Aqueous Solutions (owner) AQS-MFG-SHELL_BURNOUT-HD01
SHELL_BURNOUT fabrication drawing HD01 (AQS-PLAN-006 M3; gra
Type: fabrication drawing (GA / nozzle orientation / part sheet) Rev be365f0d Issued 2
Created: flow graph pipeline Approved: not approved (study)
Sheet 1 of 1 AQS-DWG-001

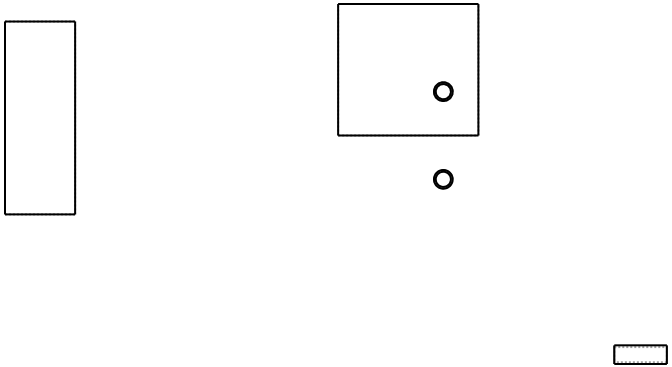
Graph revision AC - hd01: N3/N4 DN15 stubs +Y z 600; N5 off-gas collector hood -Y z 480..640
Graph revision AC - hd01: N7 vent DN15 at (400,400) to the z 800 datum
Graph revision AC - hd01: Gasket faces per AQS-PIP-003 practice (AQS-STD-002 section 14); general tolerance ISO
